**UNITED STATES
NUCLEAR REGULATORY COMMISSION
WASHINGTON, D.C. 20555-0001**

**SAFETY EVALUATION REPORT
NAC INTERNATIONAL
MAGNASTOR® STORAGE SYSTEM
DOCKET NO. 72-1031
AMENDMENT NO. 5**

Figure 4-1: PWR Four-Zone Preferential Loading

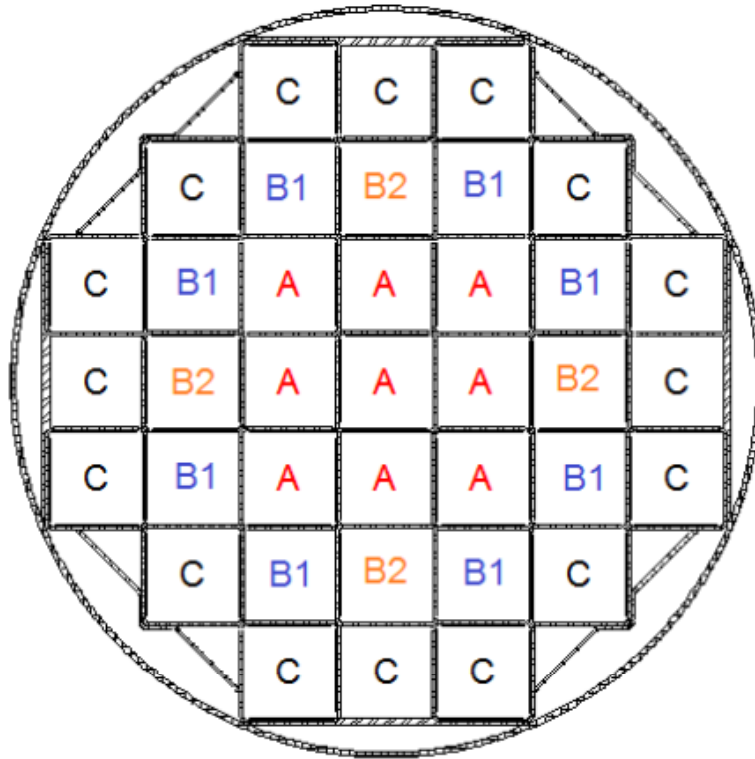
The proposed PWR fuel preferential loading configuration requests accommodation of up to 37 PWR fuel assemblies with some fuel assemblies at a reduced cooling time using a loading pattern shown in Figure 4-1, and heat load limits as shown in Table 4-1 below. The maximum heat load limits are 35.5 kW for the low burnup fuel (≤ 45 GWd/MTU) and 33.725 kW for the high burnup fuel (> 45 GWd/MTU).

The staff reviewed the thermal evaluation and finds that the proposed loading pattern with the hot fuel located at the outer zone will remove the heat more significantly, and that the calculated temperature of 630°F is far below the limit of 752°F. Therefore, the staff determines that the thermal analysis of the PWR minimum reduced cool time fuel assembly is bounded by the thermal analysis of the standard PWR fuel assembly not only for the vacuum drying operations, but also for other short-term operations. The staff concludes that the proposed loading pattern of the 37 PWR minimum reduced cool time fuel assembly is acceptable per the thermal requirements listed in 10 CFR Part 72.

In order to envelop fuel assemblies with heat loads higher than 959 W, which is the bounding heat load for uniform loading, the applicant proposed a four-zone preferential loading pattern as shown in Table 4-1 and Figure 4-1, above. Preferential and uniform loading patterns still limit the total cask heat load to 35.5 kW.
